Location of Construction: 269 Wood Side Dr <i>Grt & Isl</i>	Owner Name: Maas Edward T & Irene M Jts	Owner Address: 700 Sylvan <i>CITY OF PORTLAND</i>	Phone: 630-879-7981
Business Name:	Contractor Name: BURTON ASSOCIATES	Contractor Address: P.O. BOX 217 FREEPORT	Phone: 207688-4992
Lessee/Buyer's Name:	Phone:	Permit Type: Single Family <i>712 0792</i>	Zone: IR-1

TO: Inspections
FROM: Jay Reynolds, Development Review Coordinator
DATE: March 27, 2003
RE: C. of O. for #269 Wood Side Drive, Great Diamond Island
Lead CBL (083EE040) ID# (2002-0067)

Site Plan - minor/ minor # 2002-0067

PLOT PLAN

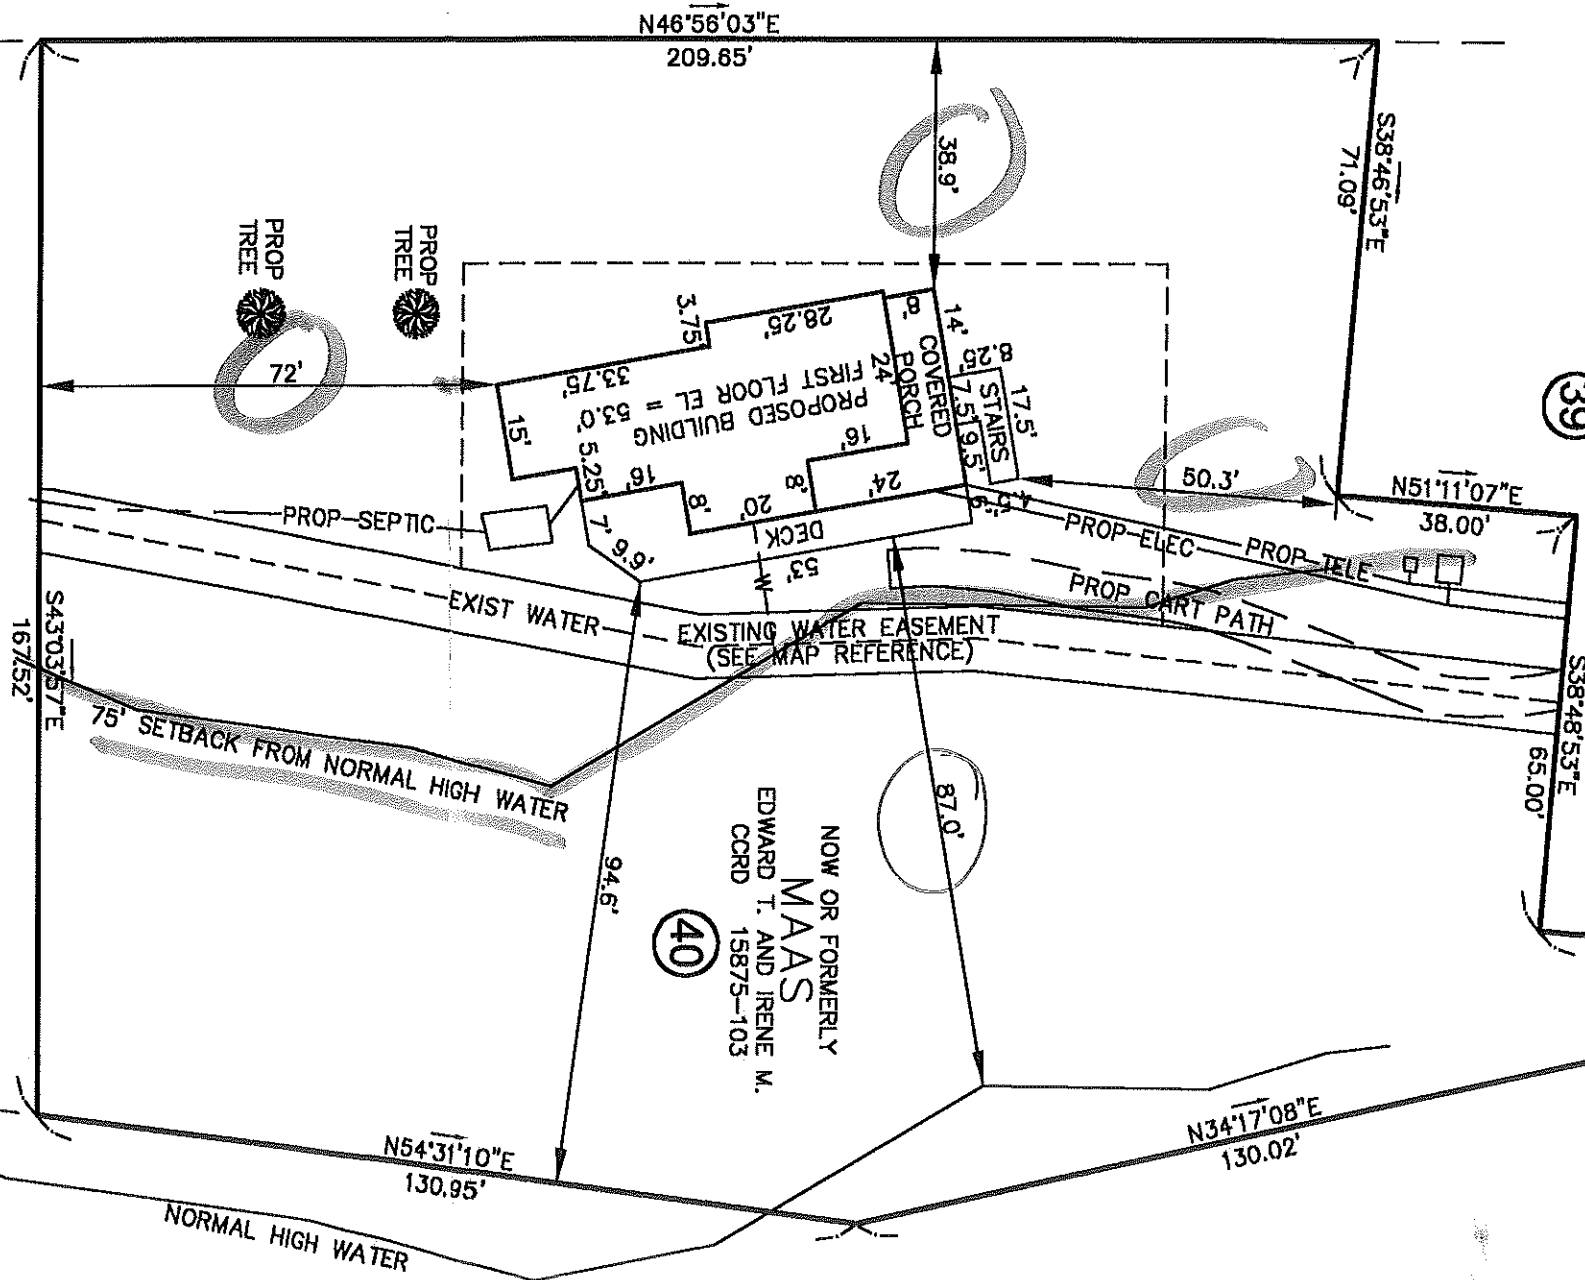
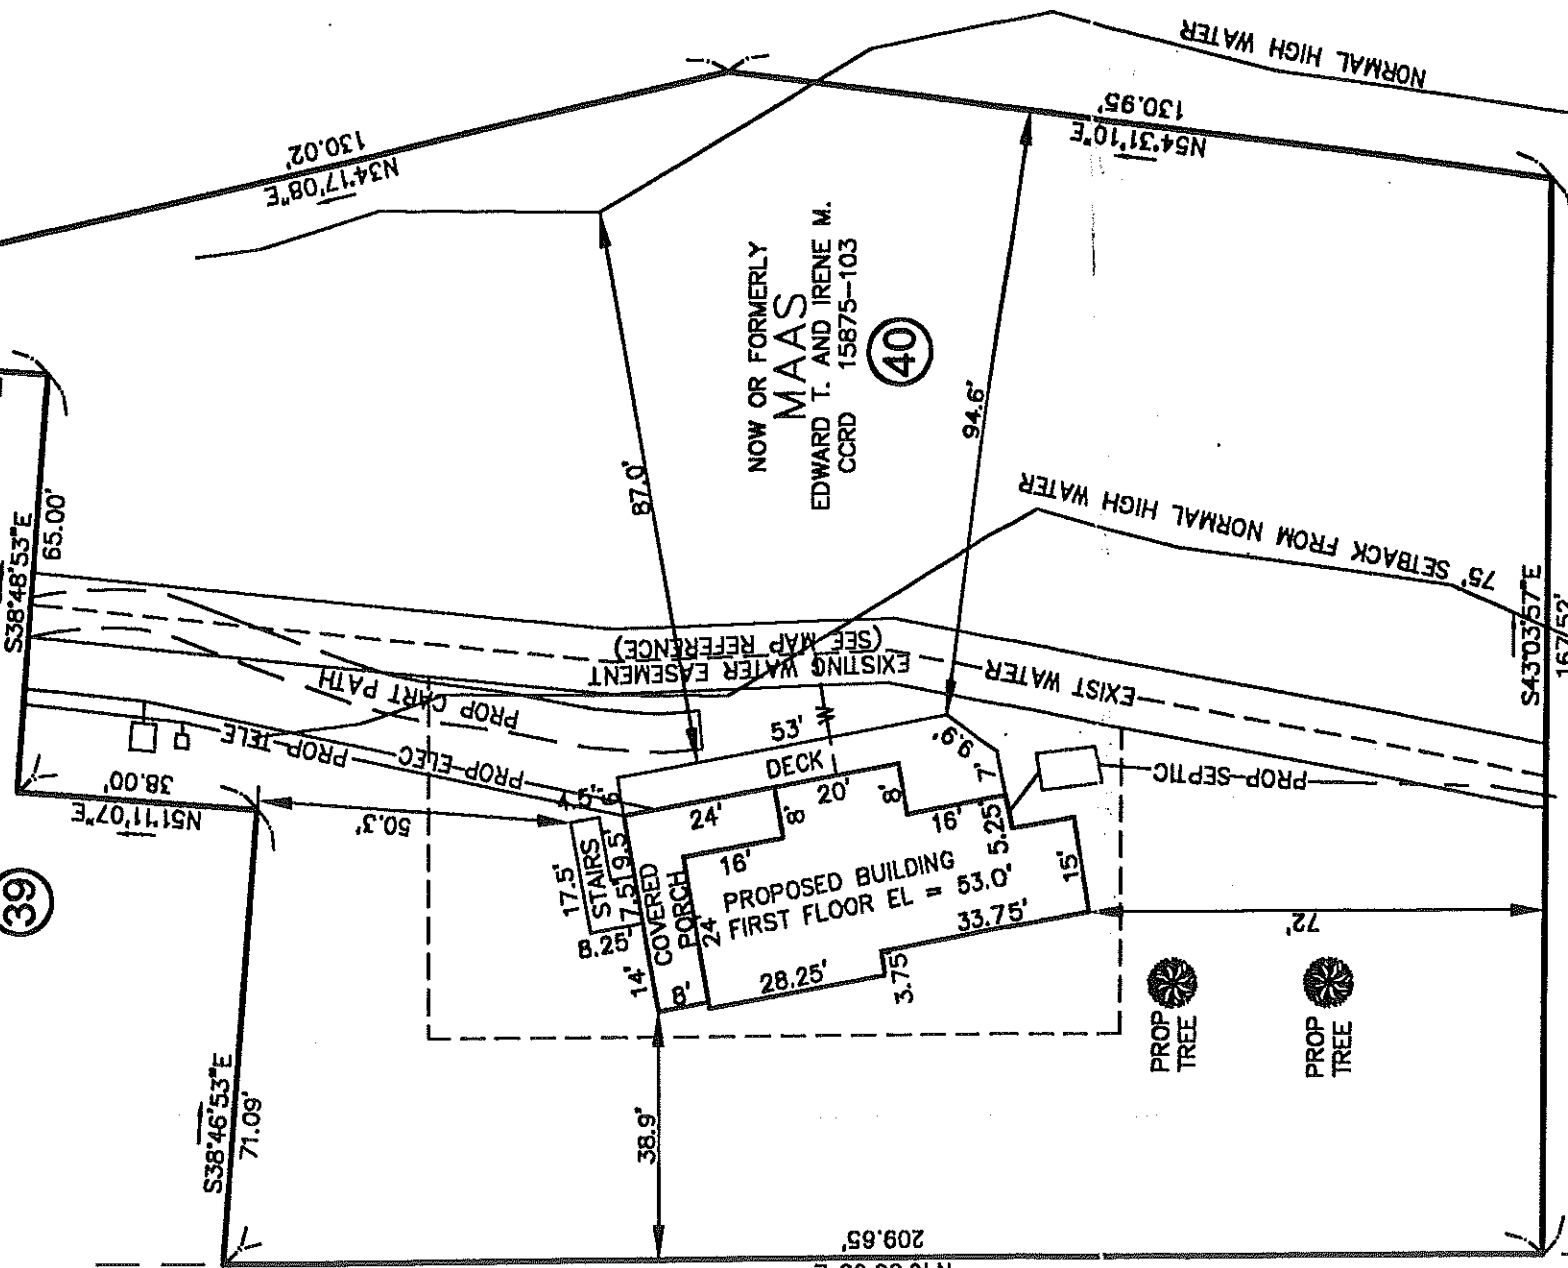
Today I received a phone call from Mary Beth Richardson in reference to the revised plans that I sent her for a new house being built at 269 Wood Side Drive (lot #40) for Maas. She has concerns about the fill being proposed within 100' of the water. DON'T ISSUE this permit until it is resolved. The owner/contractor will require a PBR (Permit By Rule) from DEP first and it will most likely be turned down. I will give the contractor a call to advise him.

Shoreland Zoning Stream Protection - within - 75' min to N.W.M. Reg.
87.0' shown on revised plans

Comments: 269 Wood Side Dr.- Great Diamond Island (lot #40)
4/1/02 Called surveyor - what is the setback to HWM - it isn't shown on the plans.
4/9/02 Spoke to David Burton - reiterated the need for showing the 75' setback from HWM
